Information request response (pursuant to Schedule 2, Part 2, Section 2.1 (6) of the Galilee Basin SDA Development Scheme (October 2015))

Your Ref: AP2025/010

We refer to the information request, dated 14 October 2025, for the SDA application for material change of use for a utility installation (water pipeline and pump station) in the Galilee Basin State Development Area (SDA).

PIPELINE IN ROAD RESERVE/ WITHIN PROPERTY BOUNDARIES TRENCH
TYPICAL INSTALLATION DETAIL
NOT TO SCALE

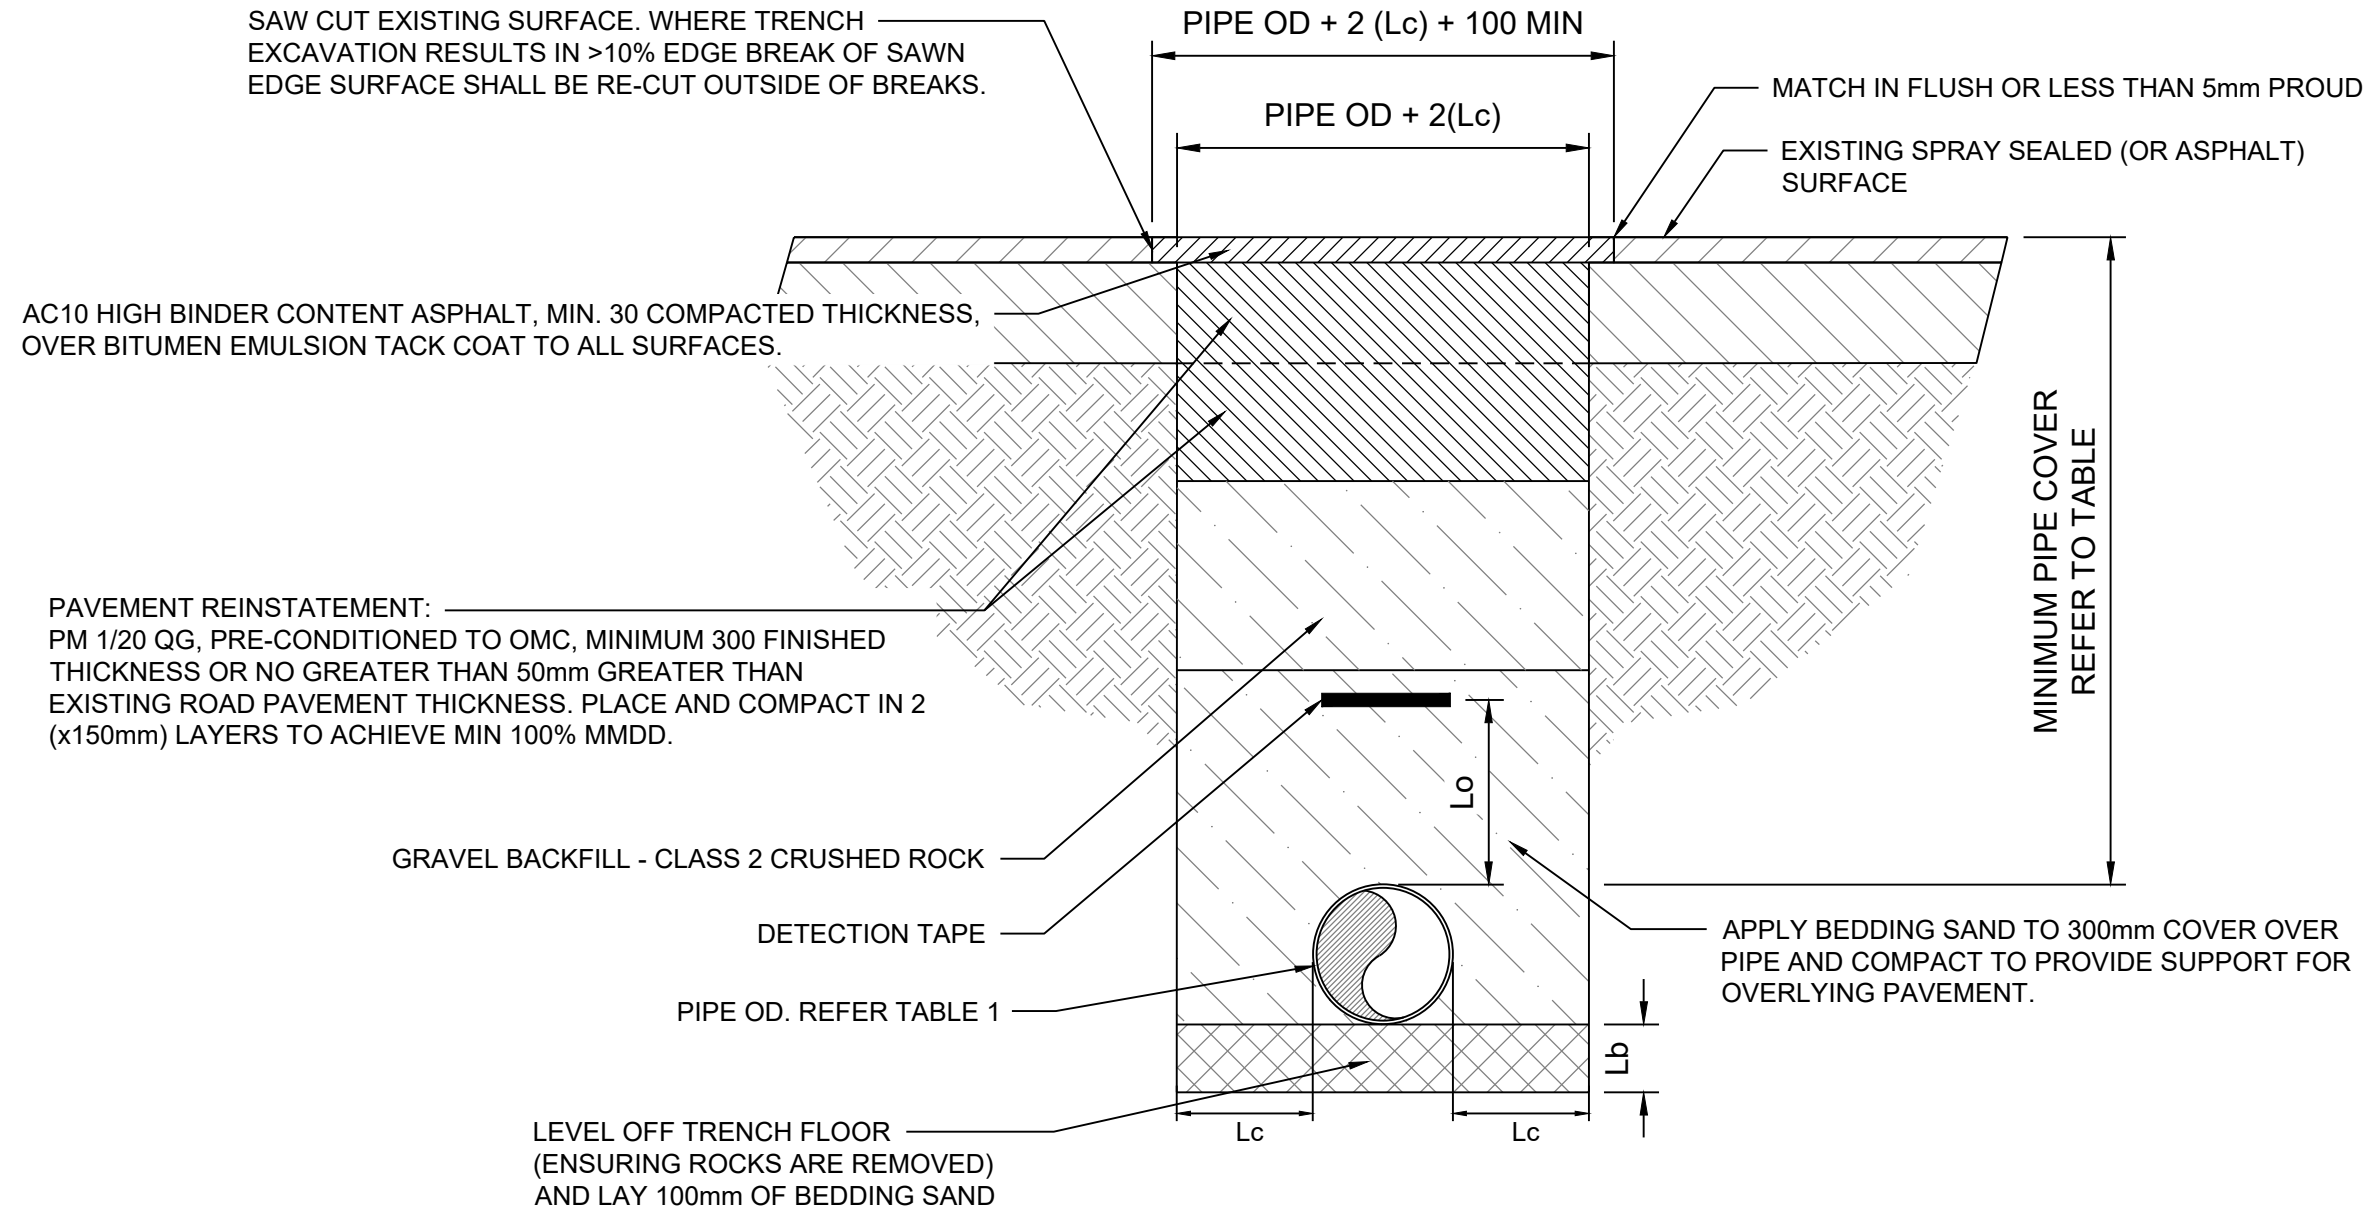
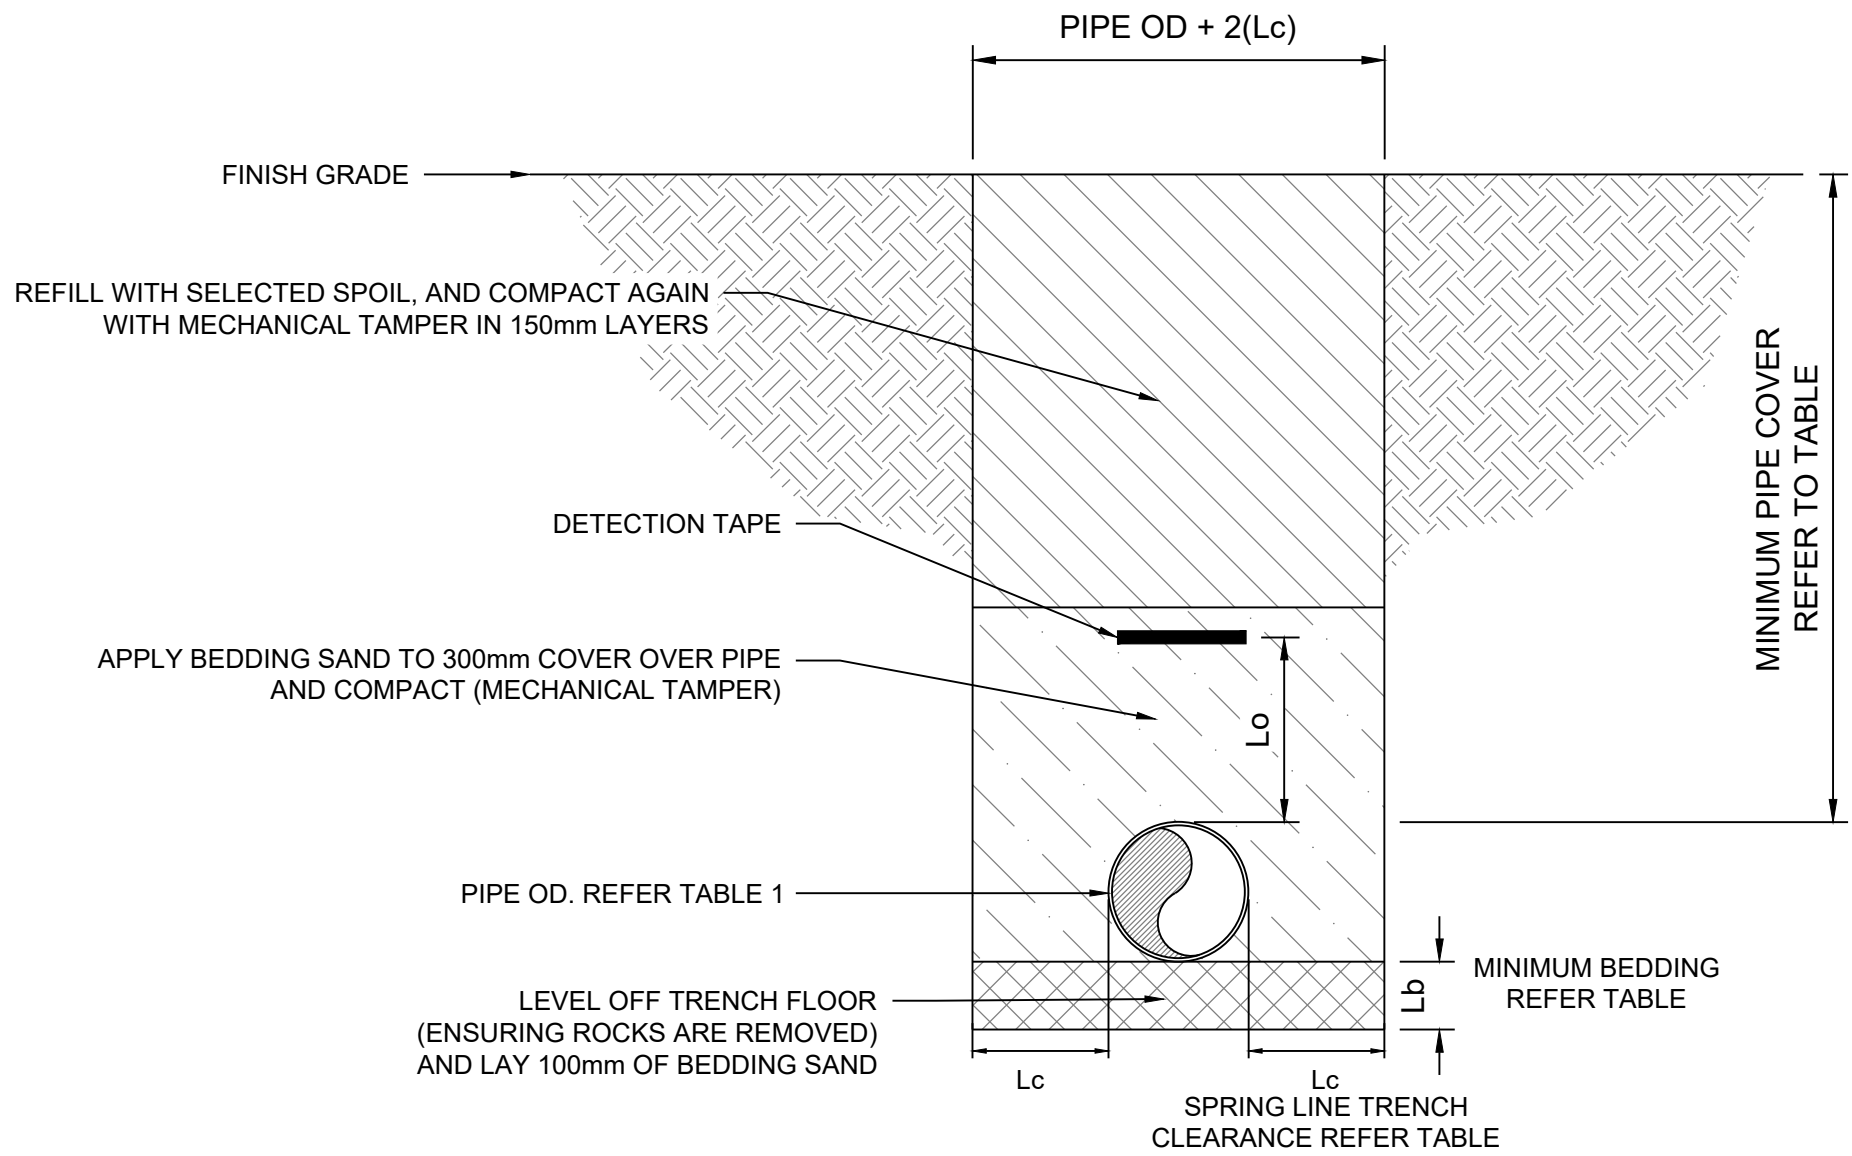
In the Rail Corridor Precinct of the Galilee Basin SDA, self-assessable development for operational works must be authorised by conditions of an SDA approval for a material change of use. To ensure the operational works are consistent with what is proposed for the material change of use and can be undertaken as SDA self-assessable development, the proponent is requested to:

1. Clearly identify the types of operational works seeking to be specified as “SDA self-assessable” i.e. civil works, clearing native vegetation etc
2. Clearly outline the extent of the operational works within the SDA that are being sought to be specified as “SDA self-assessable”.

Within the Galilee Basin SDA, the following types of operational work associated with pipeline construction / installation are proposed to be undertaken as “SDA self-assessable”, authorised under an SDA approval for a utility installation (water pipeline and pump station):

- Civil works / engineering work / infrastructure installation
- Excavation and filling
- Stormwater drainage works
- Erosion and sediment control works
- Landscaping (including revegetation and reinstatement)

Attachment A contains typical sections of trenching and trenchless installation. It is noted that these sections are preliminary only and not for construction. It is proposed that detailed design drawings of proposed operational works can be submitted to the Office of the Coordinator-General as a condition of approval.

PIPELINE 'DESIGN' DRILL ROUTE

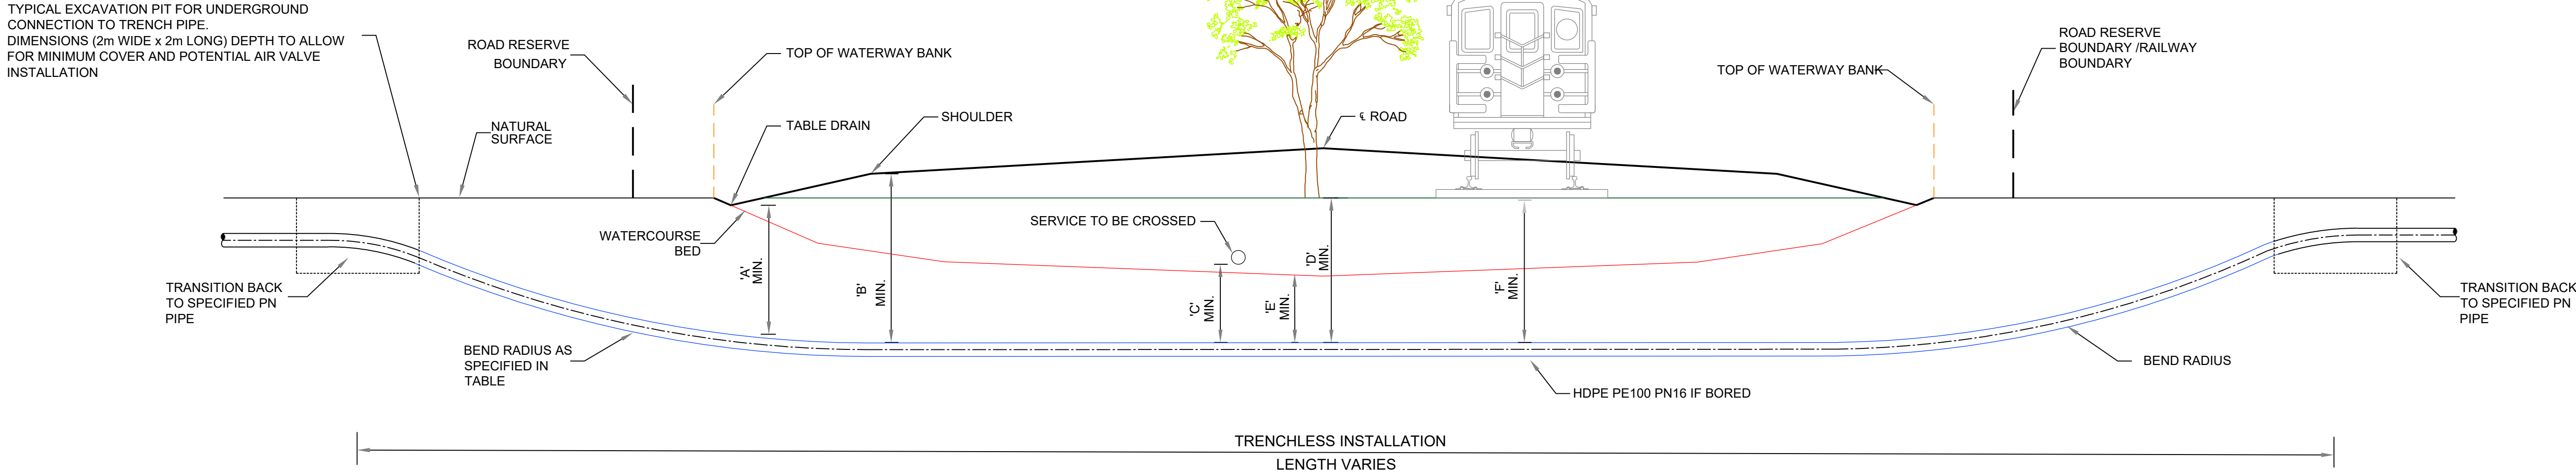
The plans provided in Appendix A identify a pipeline corridor in which the pipeline will be located where it crosses the Galilee Basin SDA. It is unclear the width of this corridor and if this will be the ongoing corridor for the pipeline operation and maintenance in the SDA.

1. Confirm the width of pipeline corridor where it crosses the Galilee Basin SDA for both construction and operational purposes.
2. Detail the location of any construction access and laydown areas in the SDA.
3. Detail how the extent of the pipeline in the SDA will be accessed for operational and maintenance purposes, if required, following construction.

All construction activities will be undertaken within the "Pipeline Corridor" shown on the submitted plans. Where the pipeline corridor crosses the Galilee Basin SDA it has a width of 20m.

As the pipeline will be installed via horizontal directional drilling, no construction access or laydown areas will be required within the Galilee Basin SDA. The necessary drill entry sites will be established on land located either side of the Galilee Basin SDA corridor.

BPC has undertaken preliminary discussions with the rail operator (Aurizon) who have provided written consent for the lodgement of the proposed MID. The final detailed design and ongoing maintenance arrangements will be subject to a future Wayleave agreement following designation of the project.
